ECN/PCN No.: 3471

For Manufacturer			
Product Description: 2.4GHz/5GHz Dual Wi-Fi External Whip Antenna		Abracon Part Number / Part Series: APAMS-121	
Affected Revision: I.R.		New Revision: A	
		Application	
<input type="checkbox"/> Series <input checked="" type="checkbox"/> Part Number <input type="checkbox"/> Safety <input checked="" type="checkbox"/> Non-Safety			
Changes:

Dual Band Wifi/Bluetooth Antenna

APAMS-121

VSWR

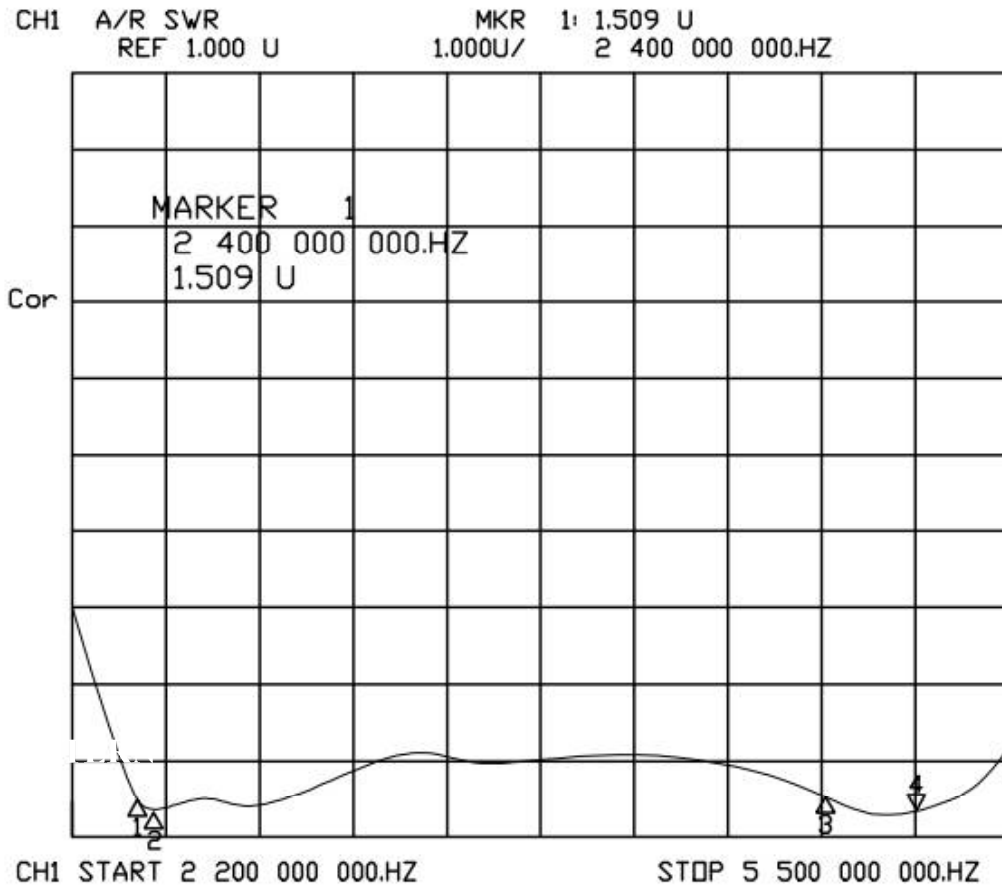
1. Specifications – Electrical, Mechanical, Environmental 2. Product Dimensions 3. VSWR 4. Radiation Characteristics			
Cause/Reason for Change: Standard product review			
Change Plan	Effective Date: 12/07/2019	Additional Remarks: N/A	
Change Declaration: The operating/storage temperature of the product has been changed which may affect the working or storage conditions.			
Issued Date: 12/07/2019		Issued By: Roshni Prasad	
		Issued Department: Engineering	
Approval: Syed Raza Engineering VP		Approval: Reuben Quintanilla Quality Manager	
		Approval: Ying Huang Purchasing Director	
For Abracon EOL only			
Last Time Buy (if applicable): N/A		Alternate Part Number / Part Series: N/A	
Additional Approval: N/A		Additional Approval: N/A	
		Additional Approval: N/A	
Customer Approval (If Applicable)			
Qualification Status:			
<input type="checkbox"/> Approved <input type="checkbox"/> Not accepted Note: It is considered approved if there is no feedback from customer 1 month after ECN/PCN is released
